Planning and Zoning Board Agenda August 11, 2020

- C. Site Plan – Burger King (16130 NW US Highway 441): A request by Robin Kendall of Quality Dining, Inc., applicant and agent, for T&H Property Group, LLC, property owner, for consideration of a Site Plan to construct a ±3,349 square foot quick service restaurant with associated parking, stormwater, landscaping, and site improvements on a ±1.19 acre subject property. Tax Parcel Number 03061-004-001 (Quasi-Judicial Hearing).

PREPARED BY: Justin Tabor, AICP, Principal Planner

SCALE: 1"=20'
DATE: 12.20.19
CAD FILE: C04-HC
JOB NUMBER: ALACHUA COUNTY
SHEET C04

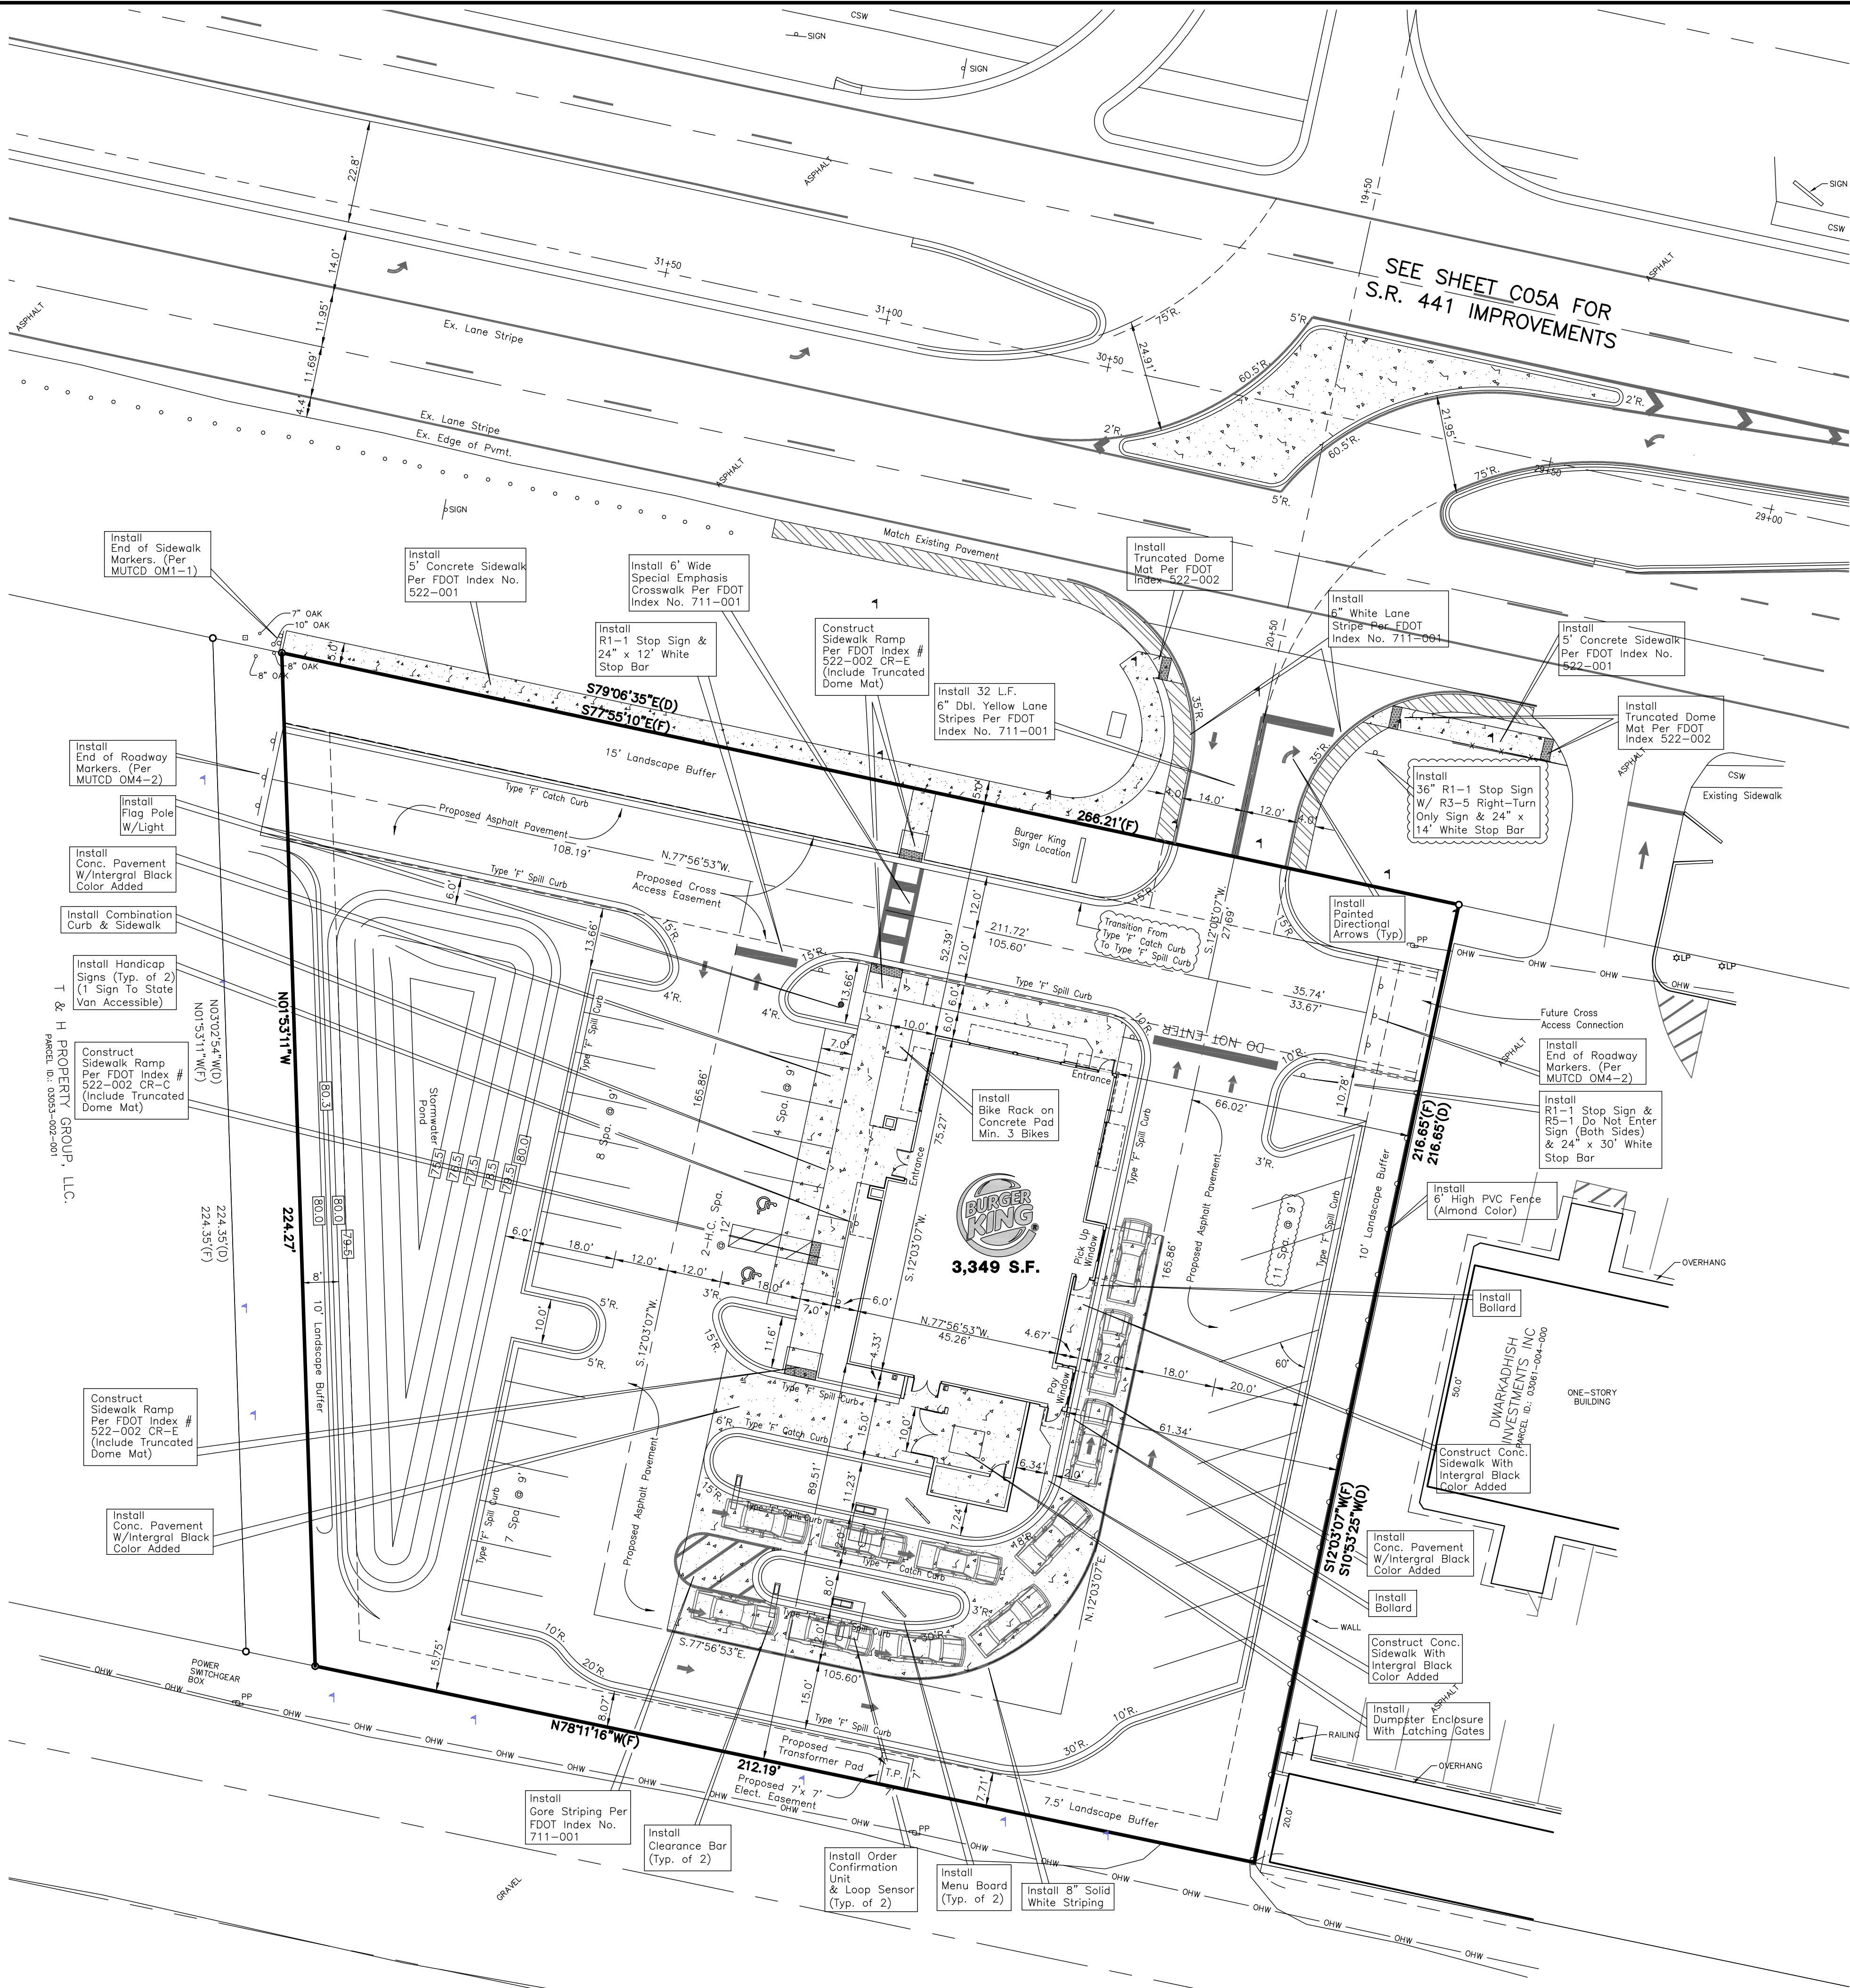
- a. Sheet C04: Update Note 7 to reflect dimensions of standard parking spaces (not all spaces are 9' x 18').
- b. Sheet EP-1: Ensure references to County Land Development Code and other jurisdictions are updated to City of Alachua Land Development Regulations / City of Alachua.
- c. Concurrency Impact Analysis: Conclusion under transportation narrative does not account for pass-by trips.
- d. Concurrency Impact Analysis: The date of the Development Monitoring Report used to prepare the analysis is January 2020 – see p. 2.
- e. Concurrency Impact Analysis: Please cite the source of solid waste impact/generation.
- f. Comprehensive Plan Consistency Analysis: Correct the reference in the first paragraph to Alachua County.
- g. Comprehensive Plan Consistency Analysis: Revise response to Policy 1.3.d.2. of the Future Land Use Element to reflect cross-access connection to the east.

- a. Sheet C04: Update Note 7 to reflect dimensions of standard parking spaces (not all spaces are 9' x 18').
Response: Note 7 has been revised.
- b. Sheet EP-1: Ensure references to County Land Development Code and other jurisdictions are updated to City of Alachua Land Development Regulations / City of Alachua.
